HN-232
DN-179
EN-70
FN-57

SERVICE BULLETIN

DATE: 27 SEPTEMBER 1991
PAGE 1 OF 5

ONE-TIME ADDITION OF RIVETS TO TAIL ROTOR ABRASION STRIP

Figure 1. Addition of Rivets to Tail Rotor Abrasion Strip, FOD Removal from Blade Interior.

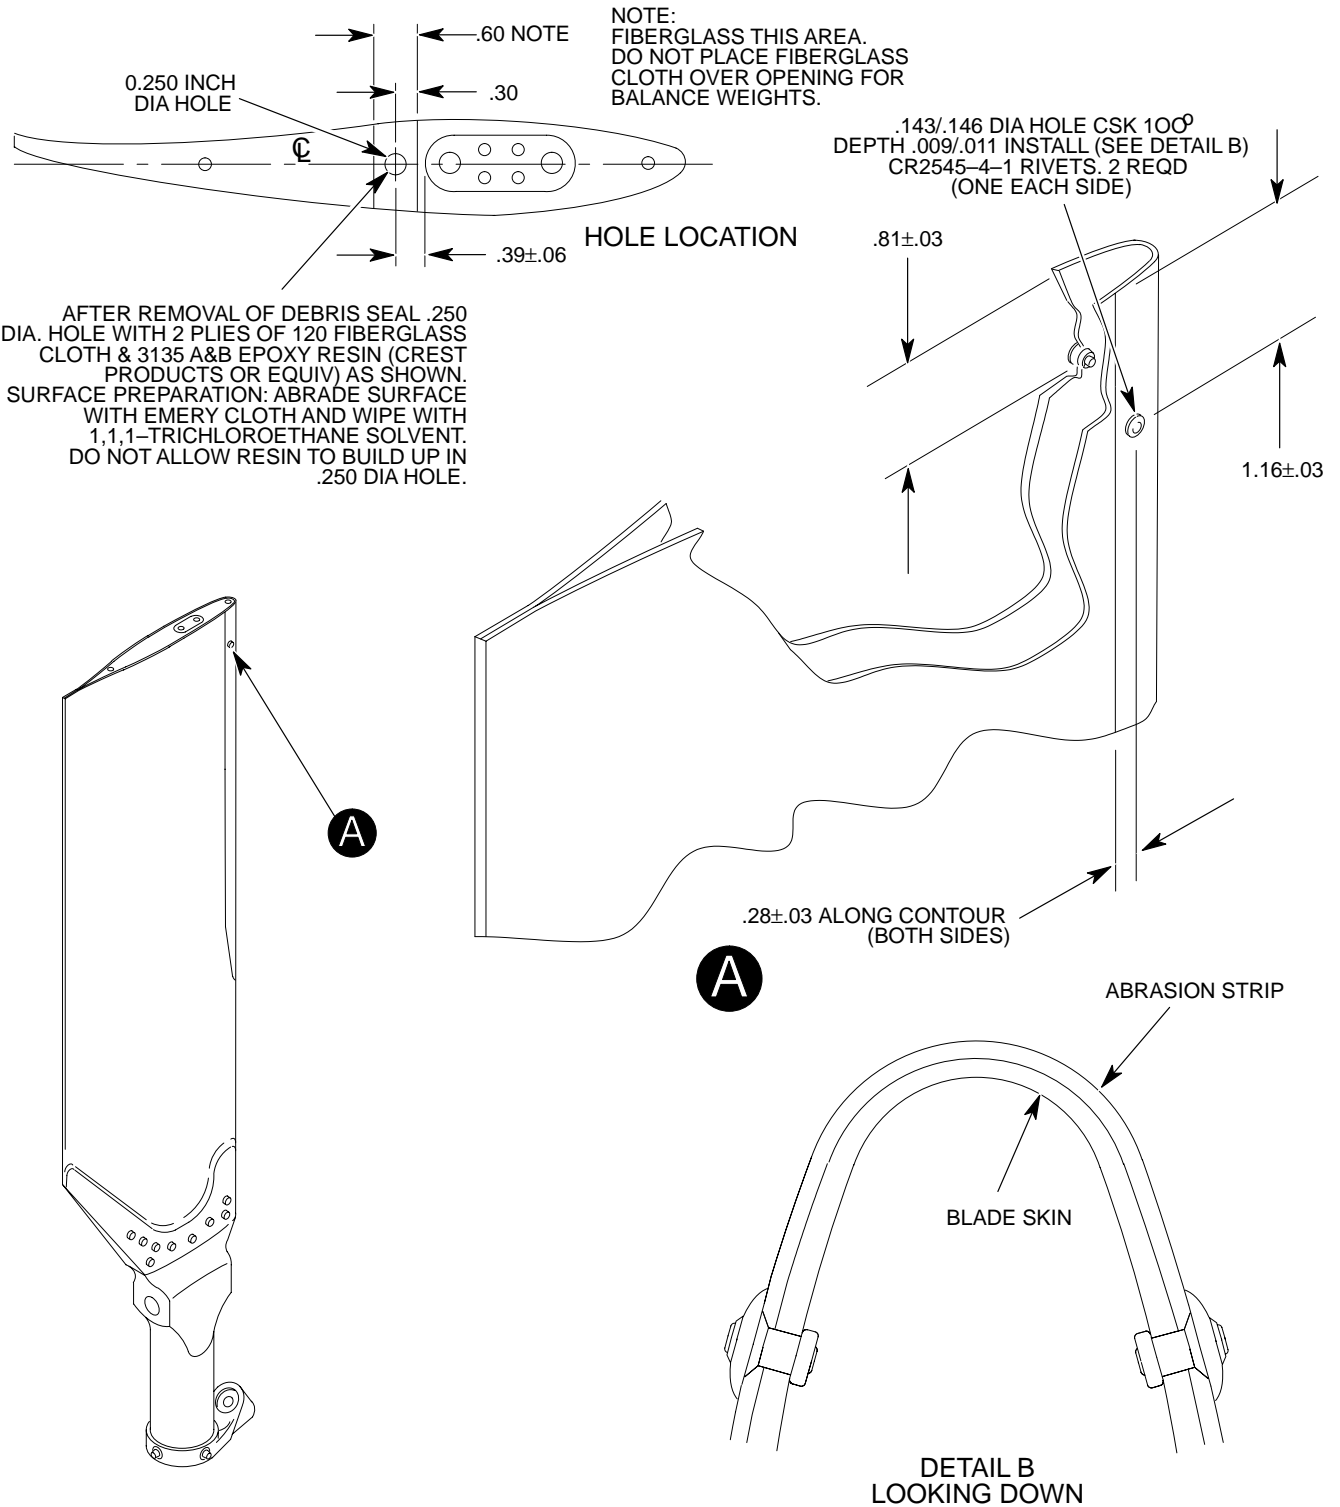
- a. Remove the tail rotor blades from helicopter per the applicable maintenance manual.
- b. Carefully secure the tail rotor blade in a suitable holding fixture.
- c. Using a No. 27 Cobalt drill, drill holes (DIA. .143/.146) at the locations shown on Figure 1. (Light center punch prior to drilling is allowed.)

- e. Apply zinc chromate primer to holes and install CR2545-4-1 or CR3555-4-1 rivets in locations shown in Figure 1 while the zinc chromate primer is still wet.

- 1). Drill 0.250 inch diameter hole through tip-cap as shown in Figure 1.
- 2). Remove FOD from blade interior through hole (there is space at tip cap end for debris to pass aft of spar).
- 3). Return to step e. above and install new rivet(s).
